RENESAS TECHNICAL UPDATE

Product Category	MPU/MCU	Document No.	TN-RA*-A0162A/E	Rev.	1.00
Title	Note for USBHS suspend/resume interrupt	Information Category	Technical Notification		
Applicable Product	RA8P1 Group RA8M2 Group RA8D2 Group	Lot No.	Reference Document	Hardware User Manual for each product (Refer table at the end of this document)	
		All

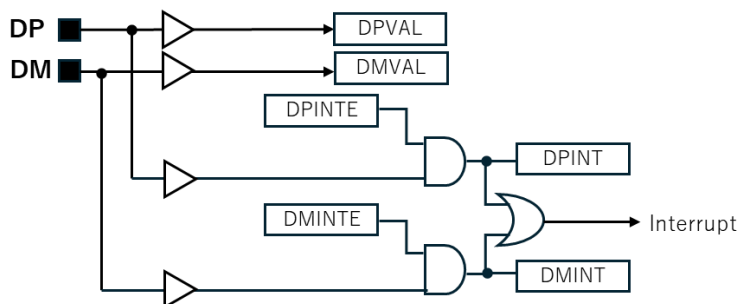
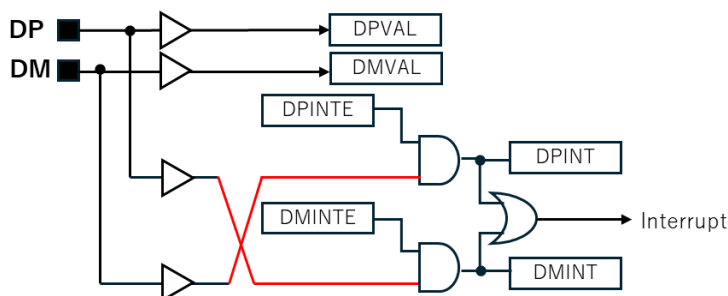
Deep software standby mode 1 is returned by a USB suspend/resume interrupt caused by a level change on the DP/DM pins, but a problem has been discovered in the circuit that generates the interrupt signal, where the DP and DM pin signals are connected in reverse.

In this case, if deep software standby mode 1 is set to be returned by a bus reset or a level change on the DP pin only upon disconnect detection, the device will not return deep software standby mode 1.

Note that resume detection, in which both the DP and DM pins change, does not affect the return operation from deep software standby mode 1.

Change the DP/DM interrupt enable bit and DP/DM interrupt indication bit as follows:

38.2.51 DPUSR2R: Exchanges bits 9 and 8, and bits 1 and 0, of the Deep Software Standby USB Suspend/Resume Interrupt Register.
